Review of Indian Point

On Thursday, March 9, I reviewed the eddy-current inspection at the Indian Point 2 power plant. The prior inspection, in 1997 had been done with probes and procedures designed to detect od defects, rather than the id defects that are present in the u-bends. In addition, the phase setting used by the utility, which is critical for id defect detection, was an old one specified for pancake probes, which is not adequate for the plus-point probe. The EPRI probe qualification for the plus-point used a correct setting in 1997 and uses the correct one at the present time. In reviewing the data, it was obvious that the phase setting was too low in 1997. This was one contributing factor to the indication being missed. The correct phase setting was already being used at this inspection when we visited the plant.

Figure 1 Impedance change due to the addition of a copper cladding on the tube at different frequencies.

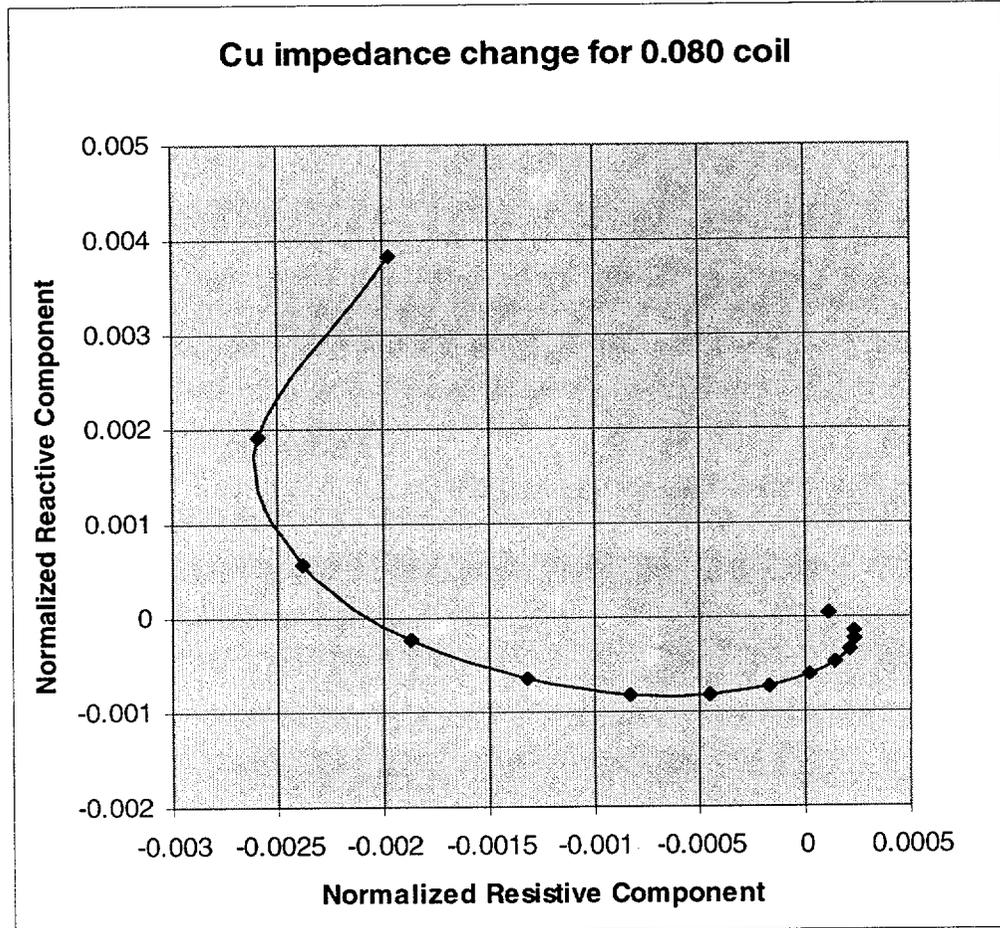
In Figure 1 the computed the normalized impedance change for a 0.080 pancake probe between no copper and an infinite thickness of copper on the outside of the Inconel tubing is shown. The frequency is increased form 300 kHz to 2 MHz in 100 kHz steps, with a jump from 1.5 MHz to 2 MHz for the last two steps. The amplitude of the impedance change at 1.0 MHz is 17.5% of that at 300 kHz, and the phase has been shifted about 90 degrees. This “noise signal” does not give a straight vector from zero thickness to infinite thickness, but will produce a “fish-hook” shaped vector. Due to edge effects and other

Figure 2 Response of a 0.080-inch probe to notches, copper and lift-off at 300 kHz.

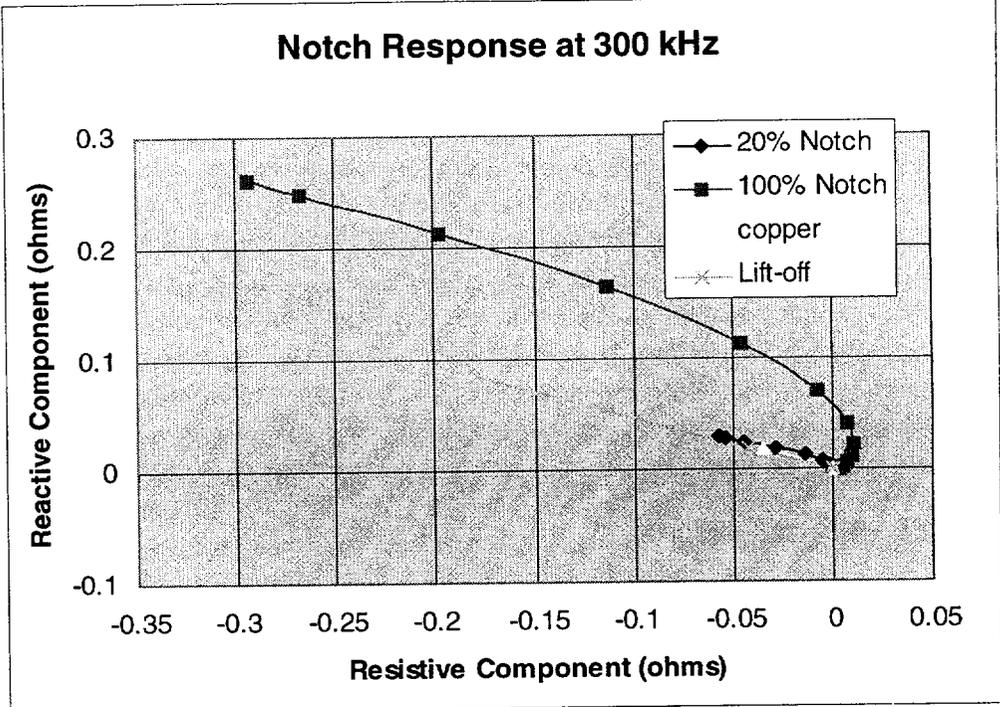
inch probe at 300 kHz. (The modeling has not been done for the plus-point probe, but the media effects will be somewhat similar.) Note that the phase orientation of the 20% notch, the copper coating and the lift-off signal all have about the same phase shift. ODSCC defect signals in the generator have amplitudes of about 10% of the notch amplitude, but the same phase. Therefore, as can clearly be seen, the defects are impossible to separate from the noise.

Figure 3 Response of the probe at 1 MHz.

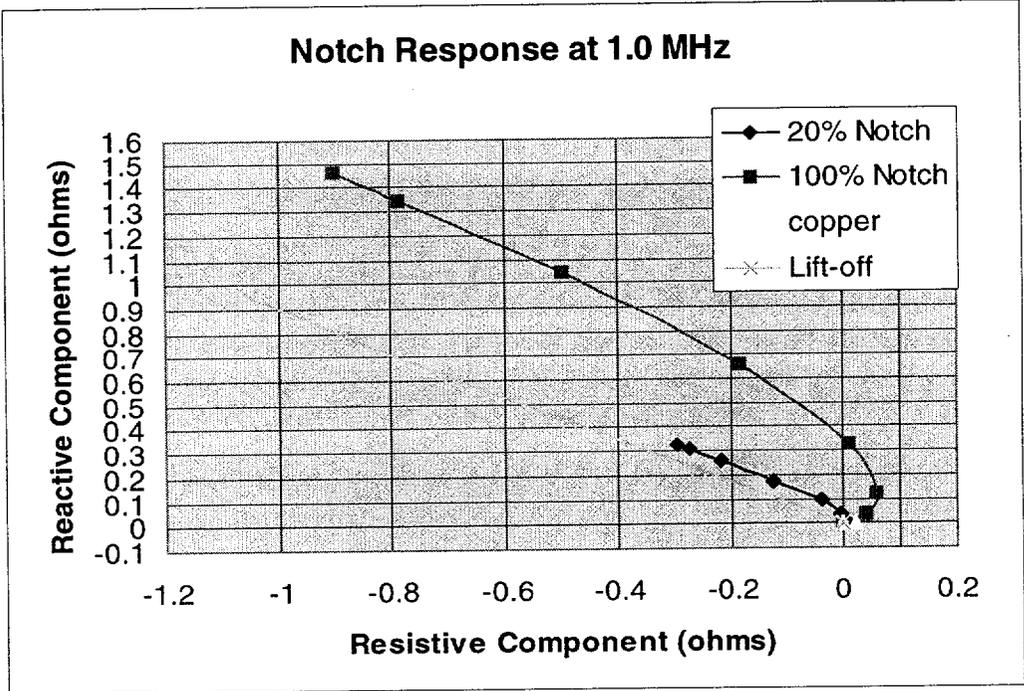
By contrast, at 1 MHz the phases and amplitudes are much more favorable. In Figure 3 we show similar plots made at the higher frequency. There is more separation of the 20% notch and the lift-off. Also, the copper signal has rotated around until it is almost horizontal. This considerably reduces the effects of the noise signals on the detection of the defects. There is more phase spread between the 20% and 100% notches, which allows a more accurate sizing.

Figure 4 Plot of 1997 scan of tube 2-72 of steam generator 24 made at 400 kHz made with midrange plus-point.

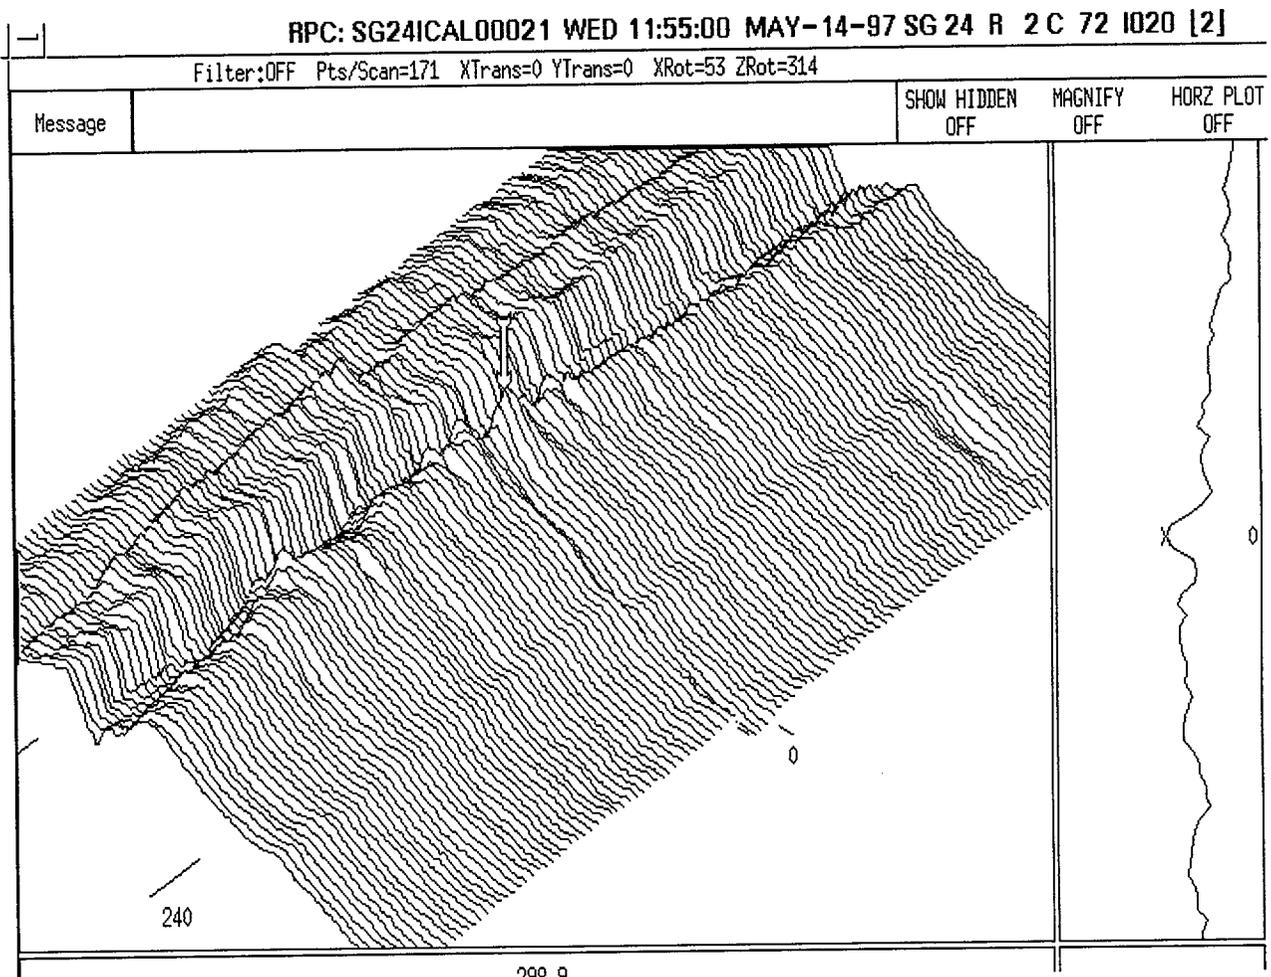
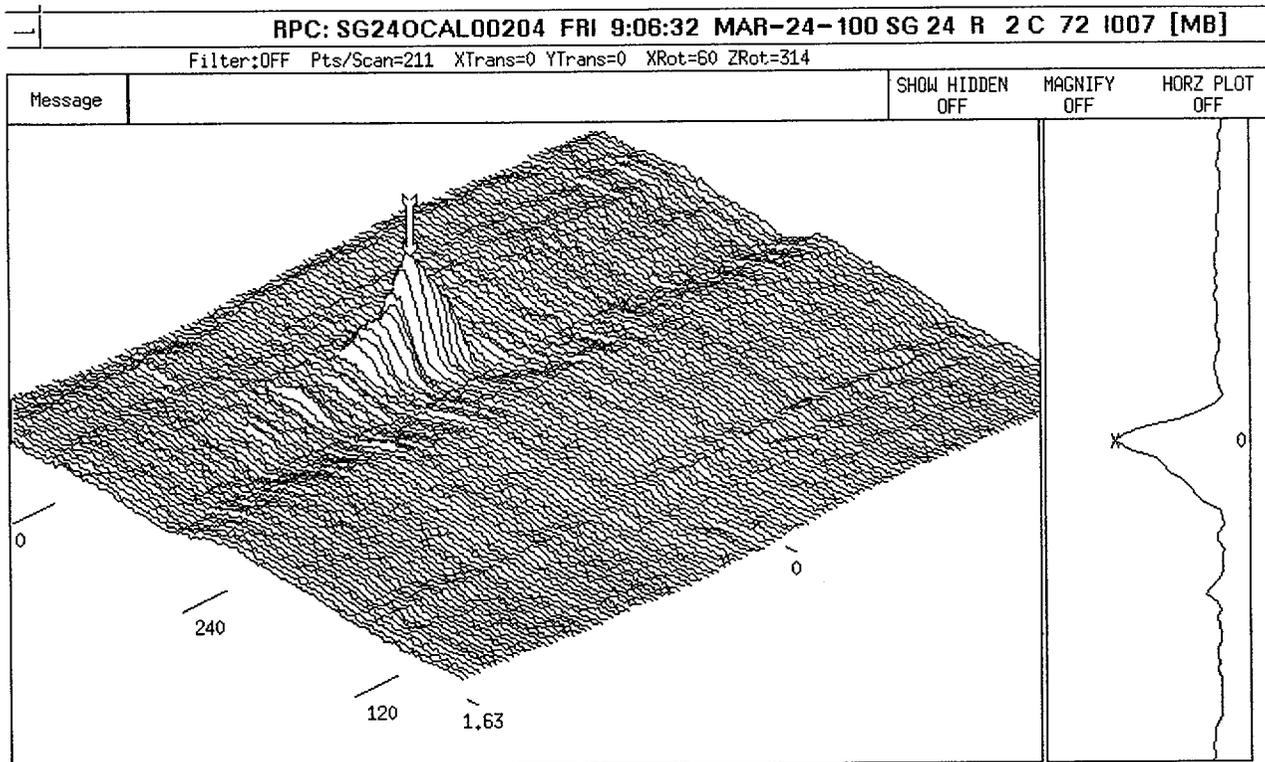
In Figure 4 we show a scan of the midrange plus-point, using the present phase setting. The indication is barely visible, and was not called in 1997. In figure 5 we show a scan of the same tube using the small, high-frequency plus-point, that has been calibrated in a similar manner. The improvement in the signal-to-noise ratio makes this defect very easy to detect. The reduction in noise will also allow more accurate profiling of the cracks. The signal-to-noise

improvement is partially the result of the probe being made smaller also. The new probe has less noise at the 300 and 400 kHz frequencies than the old mid-range probe has.
